Access Compliance Report

Public Rights-of-Way

(Curb Ramps)

Intersection ID: N/A	Main Street: SHASTA_LN	Cross Street: SHASTA HILL_CT	Location: E
ADA ID: 78CA551B92DB	Ramp Type: Directional1	Initial Pass/Fail: Fail	Overall Compliance: No
Codes/Mitigation Info/Possible Solution		Field Measurements/Component Compliance

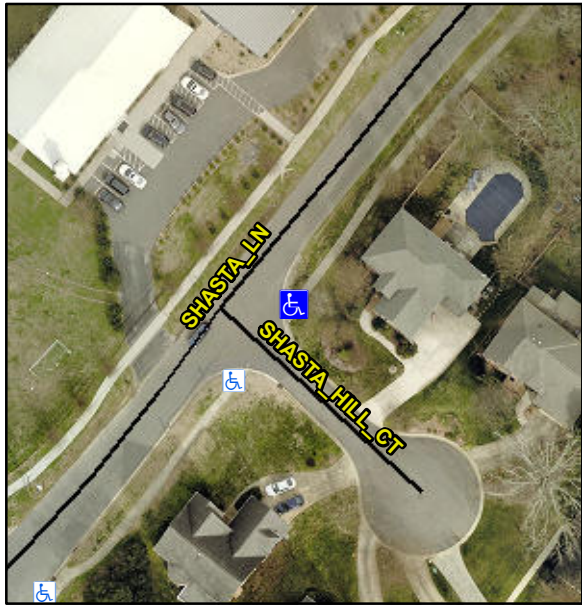
Compliance	Description	Data	Compliance	Description	Data
N/A	Ramp Length (in)	66.5	N/A	Grade Break?	N/A
Yes	Ramp Width (in)	58.0	N/A	Grade Break Slope (%)	0.0
Yes	Ramp Slope (%)	3.8	N/A	Grade Break XSlope (%)	0.0
No	Ramp XSlope (%)	3.0			
N/A	Flare Type LT	N/A	N/A	Flare Type RT	N/A
N/A	Flare Slope LT (%)	N/A	N/A	Flare Slope RT (%)	0.0
N/A	Flare Traversable LT?	N/A	N/A	Flare Traversable RT?	N/A
N/A	Landing Length (in)	0.0	N/A	DWS Provided?	N/A
N/A	Landing Width (in)	0.0	N/A	DWS Contrast?	N/A
N/A	Landing Slope (%)	0.0	N/A	DWS Length (in)	N/A
N/A	Landing X Slope (%)	0.0	N/A	DWS Full Width?	N/A
N/A	Landing Curb? (Y/N)	N/A	N/A	DWS Offset LT (in)	N/A
N/A	Shared Landing?	N/A	N/A	DWS Offset RT (in)	N/A
N/A	Gutter Ponding?	0.0	N/A	Gutter Slope (%)	N/A
N/A	Gutter Lip Ht (in)	0.0	N/A	Gutter X Slope (%)	N/A
N/A	Painted X Walk1?	No		Road Slope (%)	0.3
	X Walk 1 Direction	To SW		Road X Slope (%)	2.3
	X Walk 1 Width (in)	N/A		Clear Space?	N/A

X Walk 1 Slope (%)	0.3	N/A	Clear Space to XWalk (in)	N/A
	X Walk 1 X Slope (%)	2.3	N/A	Storm Grate/Utility Hazard?	N/A
N/A	Ramp inside XWalk1?	N/A		Storm Grate/Utility Type	
N/A	Any Obstructions?	N/A			N/A
	Obstruction Type		Yes	Surface Condition? (G/P)	Good
		N/A	N/A	Curb Slope (%)	19.5

Possible Solutions:

Remove & Replace Entire Ramp.

R304.5.3
